Water Utility Services

Date: **02/22/2023**
RFB No: **2023-007**
Commodity: **WMARSS Aire Line Replacement Project**
Purchasing Agent: **Daryle Bullard**

Addendum No: 1

Questions and Answers from the pre-bid meeting and thereafter:

NOTE: THIS CHECK VALVE IS NOT SPRING LOADED, THEREFORE, VALVE MUST BE INSTALLED EITHER HORIZONTALLY WITH THE SHAFT VERTICAL OR VERTICALLY WITH FLAPS UP.

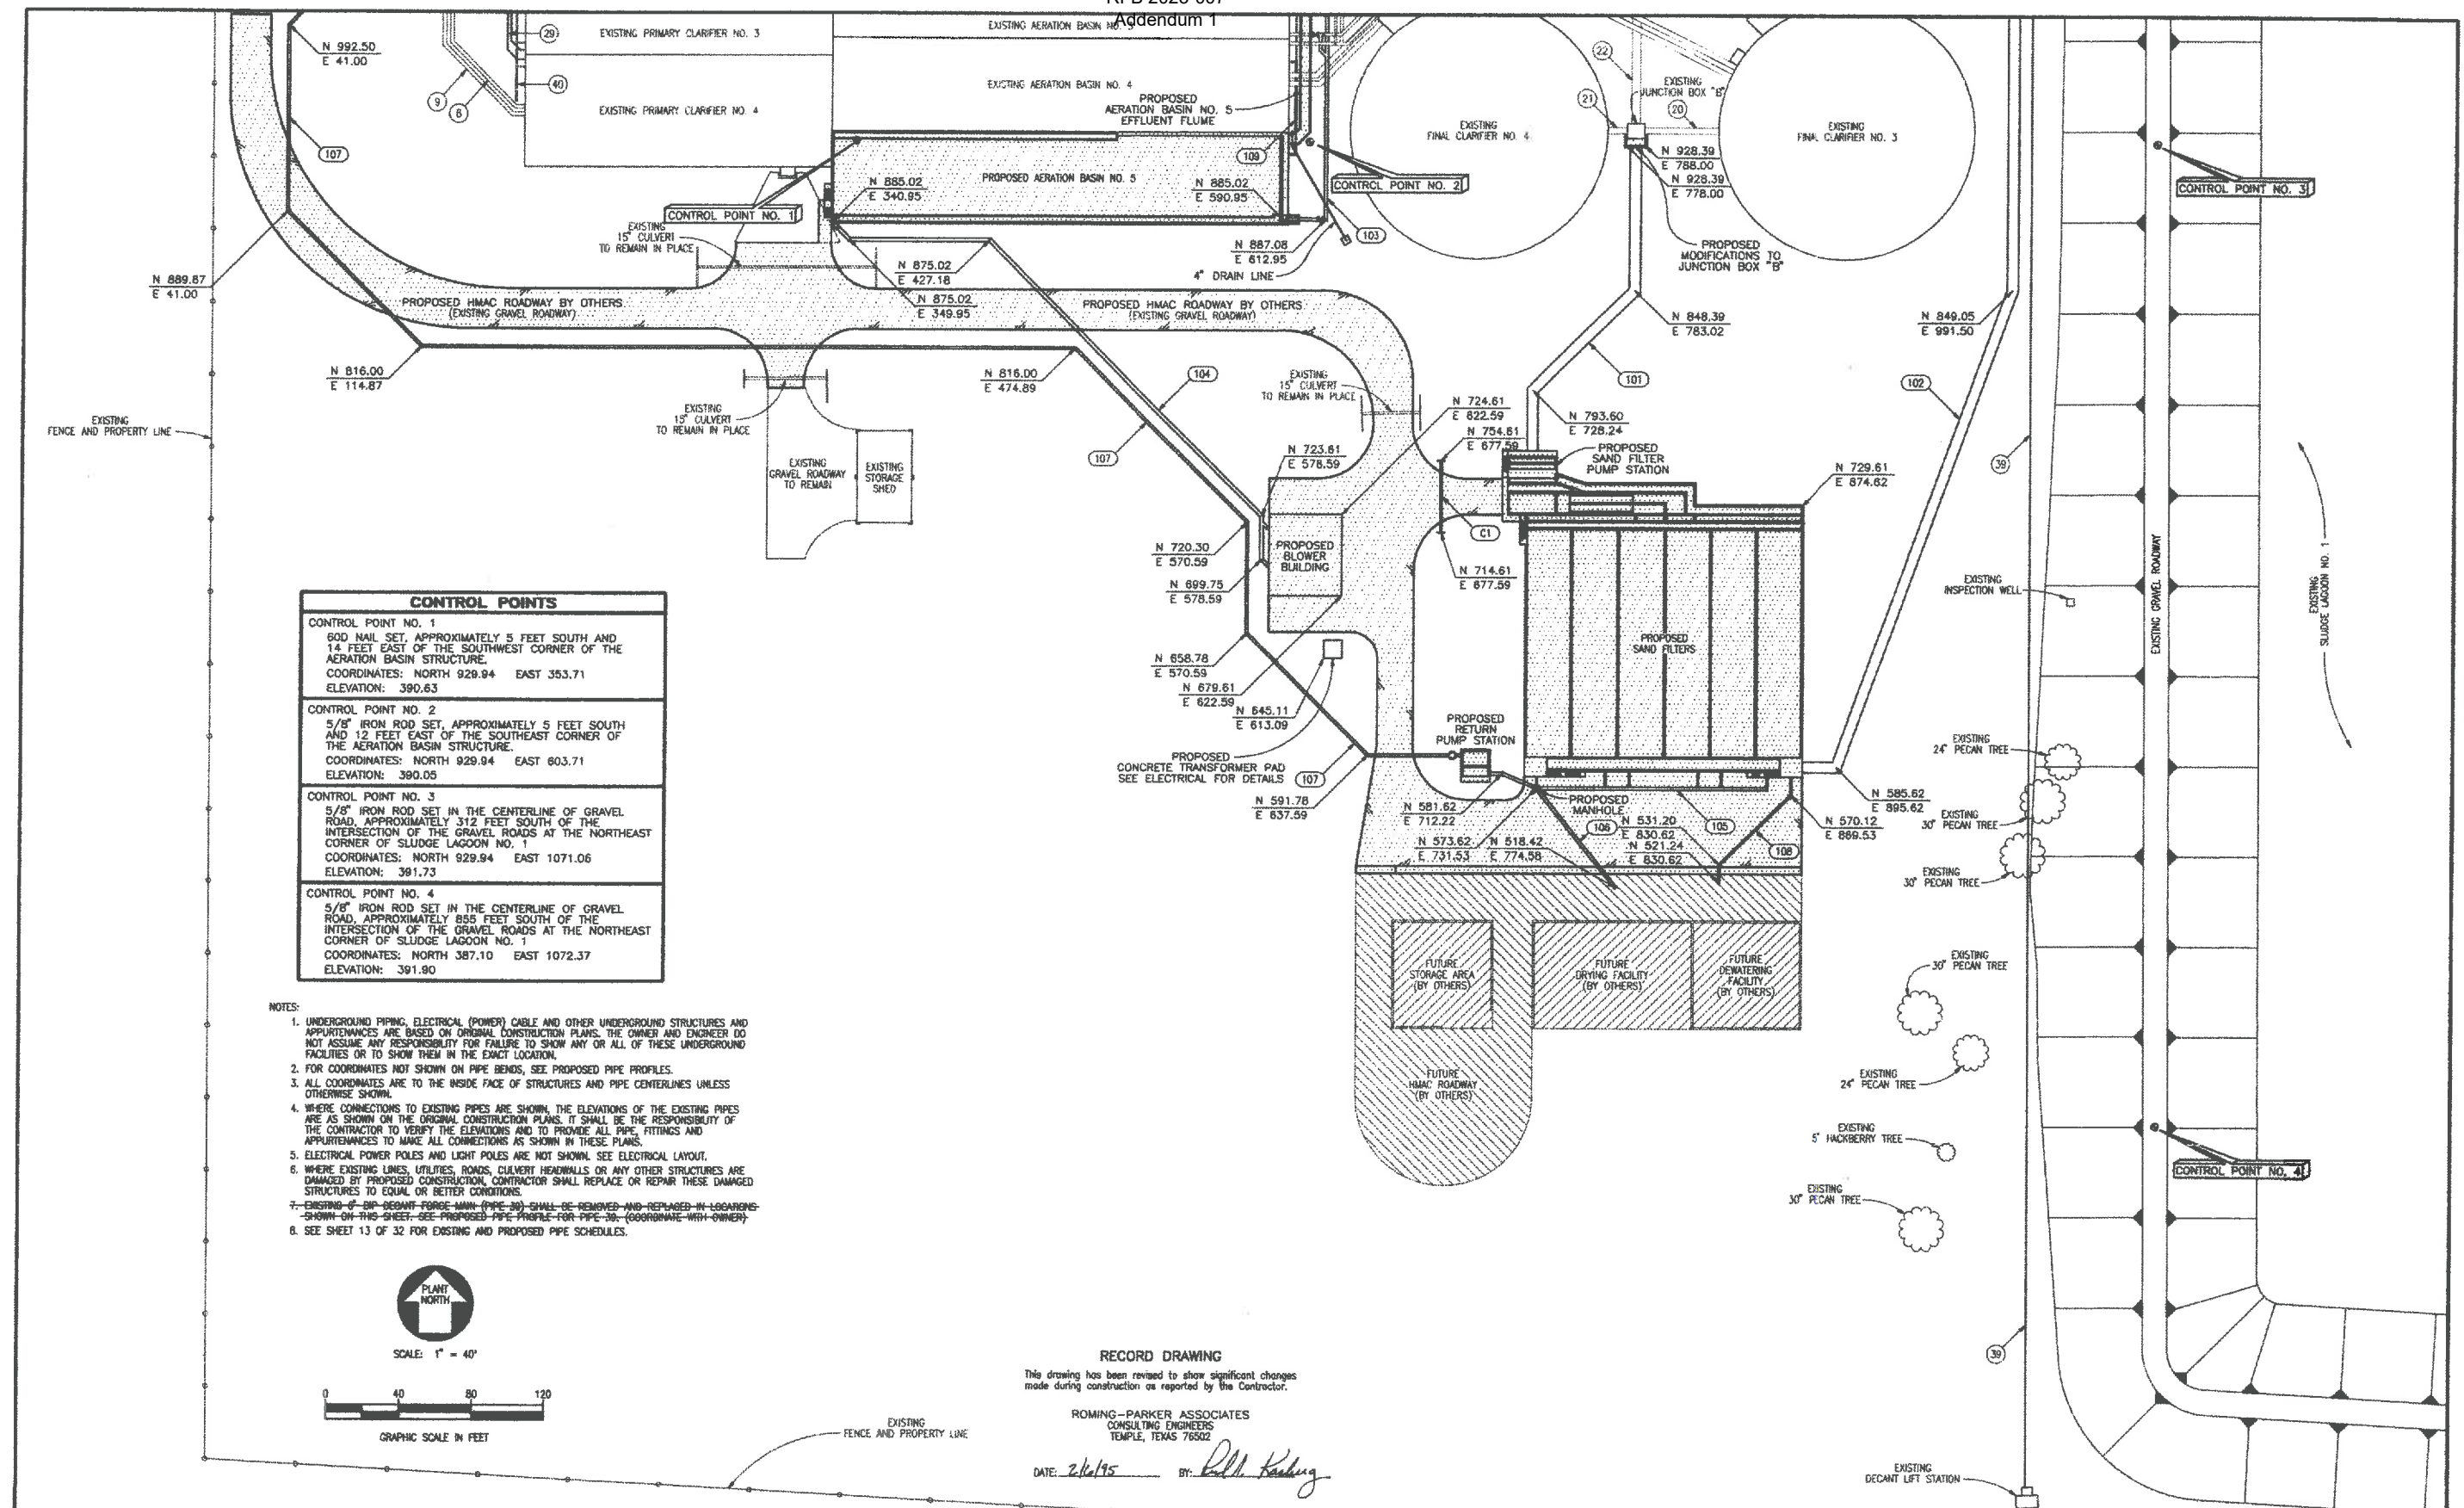
5. Does the thermo-weld have to be replaced?
The thermo-weld is to be reused.
6. Does the contractor have to supply the check valves?
No. The City will provide the check valves as a part of the overall pipe purchase.

PROPOSED PIPE PROFILES
PIPE NUMBERS 104, 105, 106, 108 AND 109

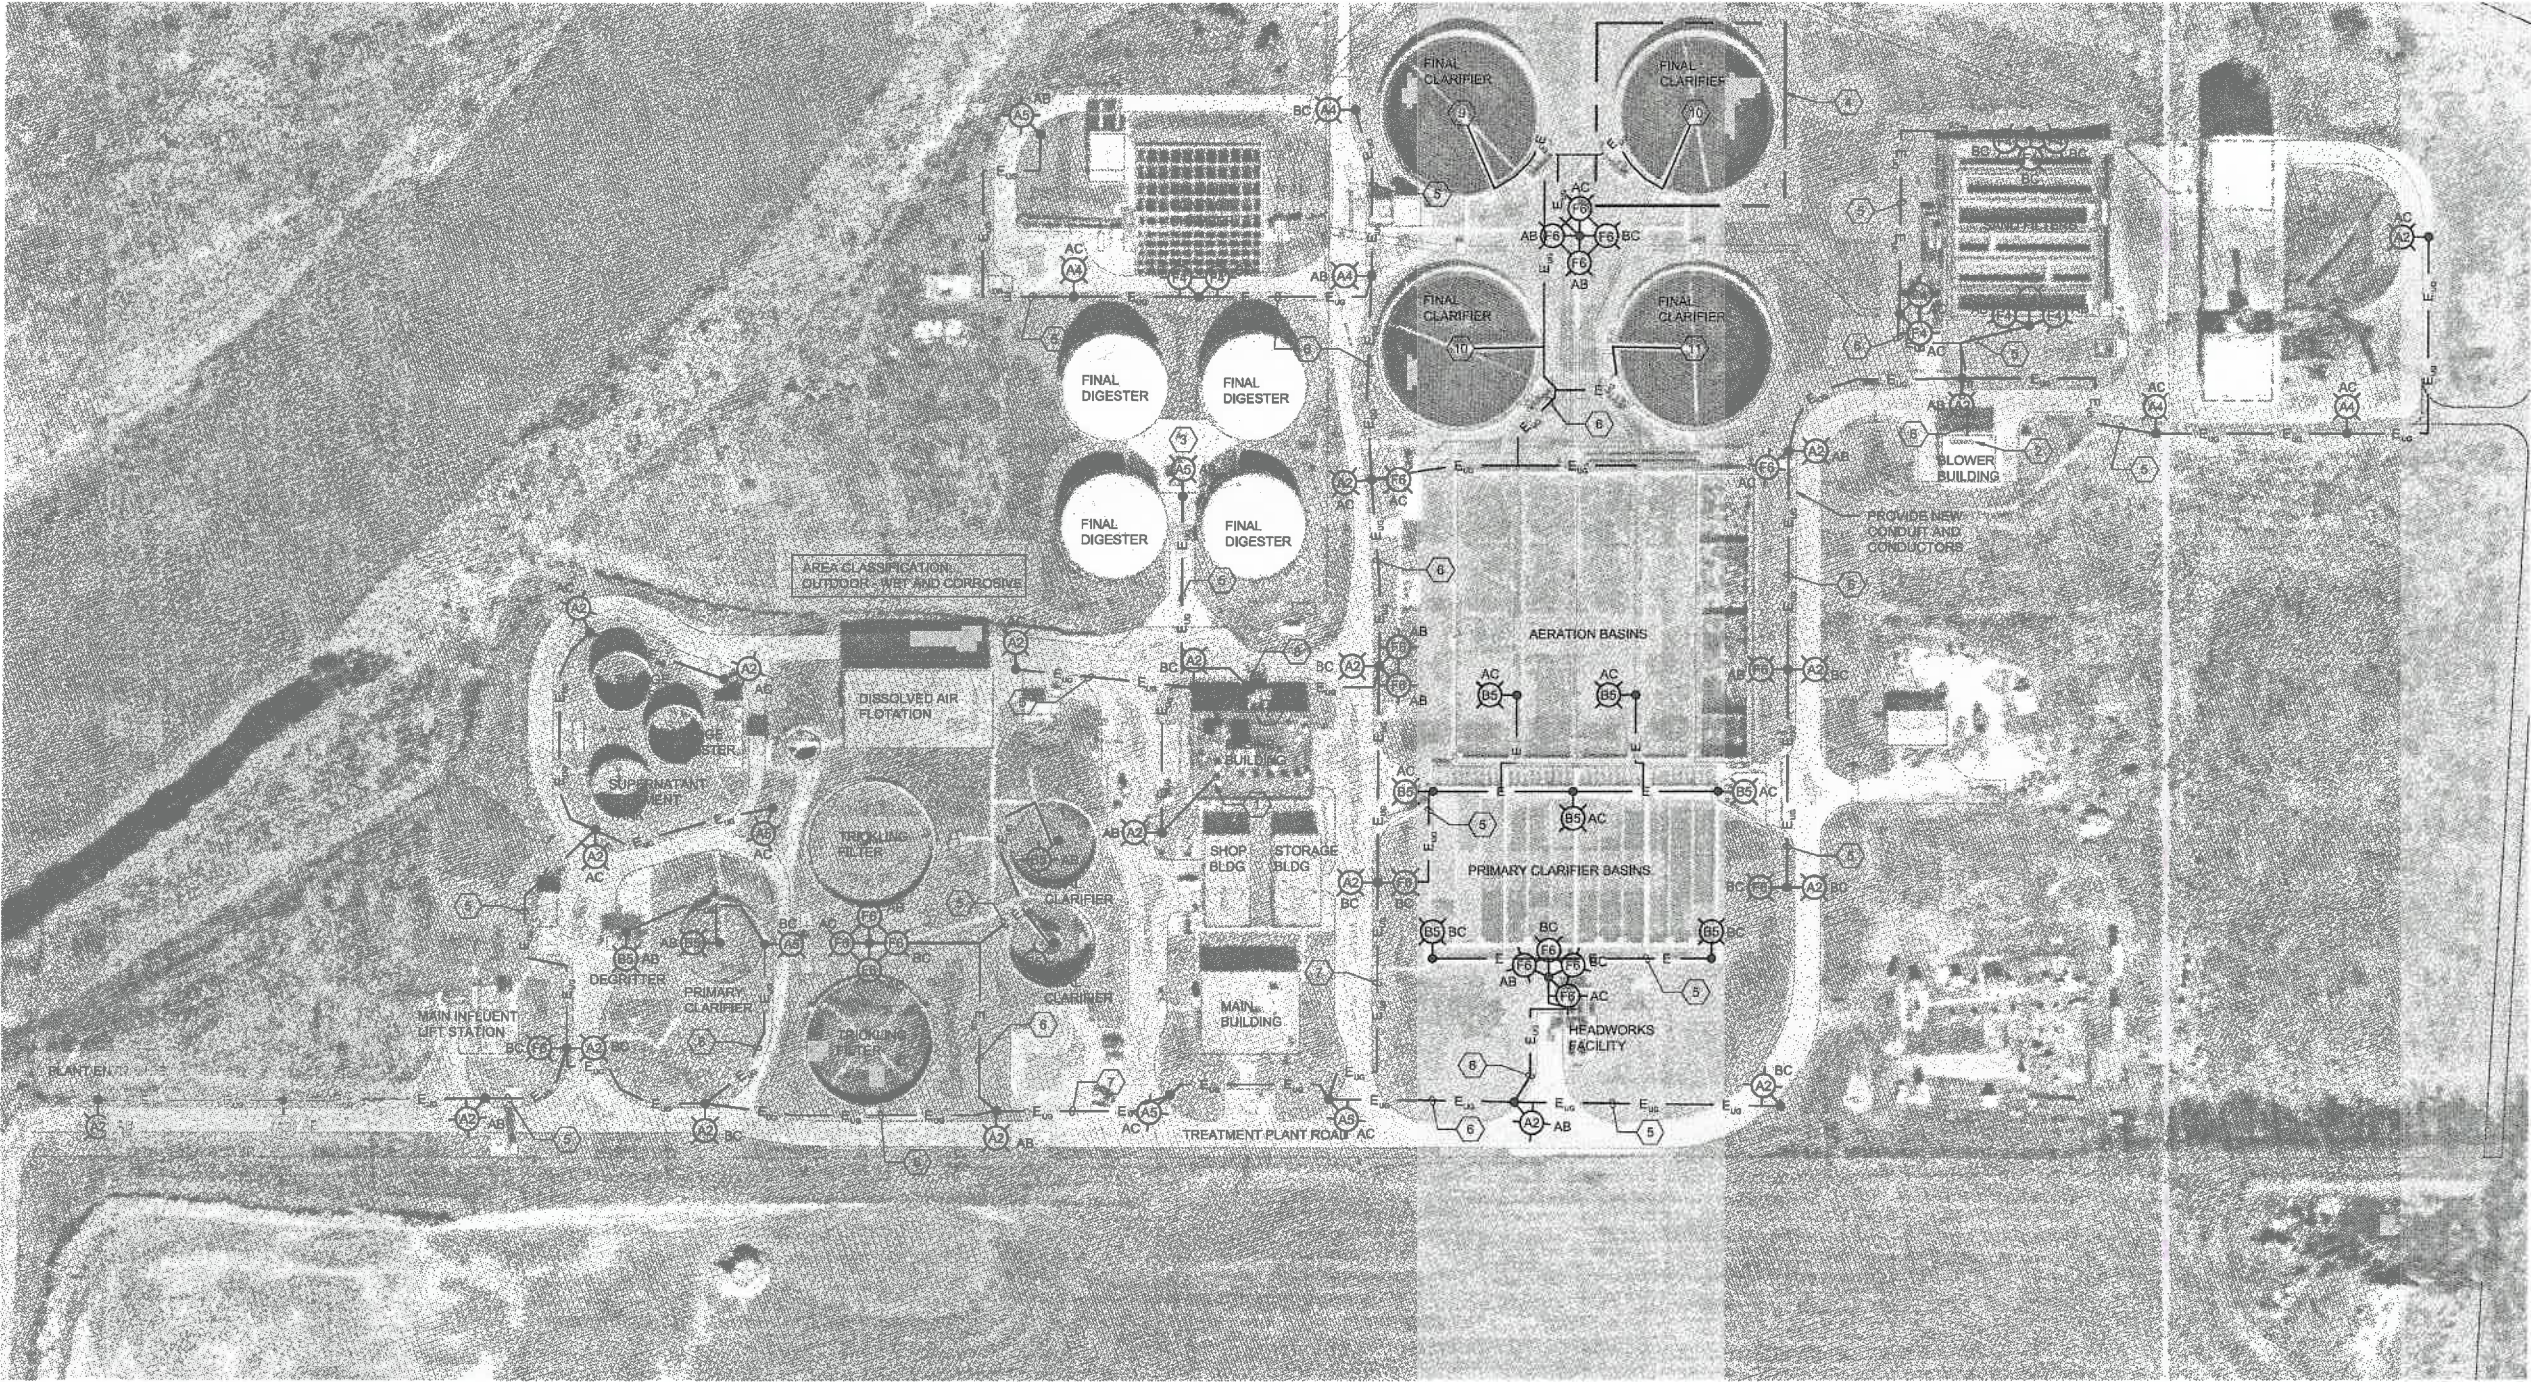
2. I had asked a question on Public Purchase about better plan sheets with profiles for the 24" line.
See attached.
3. I was wondering if you know the engineers estimate for WMARSS Airline Replacement Project for the City of Waco - RFB No. 2023-007
We do not have an engineer's estimate for this project.

9. Can we get a detail drawing of the pipe you are purchasing so we can better understand of the below ground connections? We don't want to assume the connection type to be made and prepare for the wrong connections. As it is stated in the RFQ the testing is an important part of this bid and leak free is a must.
We do not have detail drawings of the pipe we are purchasing. However, the attached profile sheet may have some information that maybe useful. We will be purchasing push on joint DIP for the buried sections and flanged pipe for the above ground

sections. The concrete encasement shown on the plans is to be replaced as a part of this project. Specific pipe details are as follows:

- All the DIP is to be unlined
- The buried section of pipe is to have zinc coating and be restrained
- V-Bio wrapping will be used for the buried section of the pipe
- FKM Gaskets will be used for the buried section of the pipe
- The fittings are to be 350 Class rated
- The pipe is to be 150 Class rated
- All of the 18-inch DIP and 50 feet of the 24-inch DIP will have flange fittings
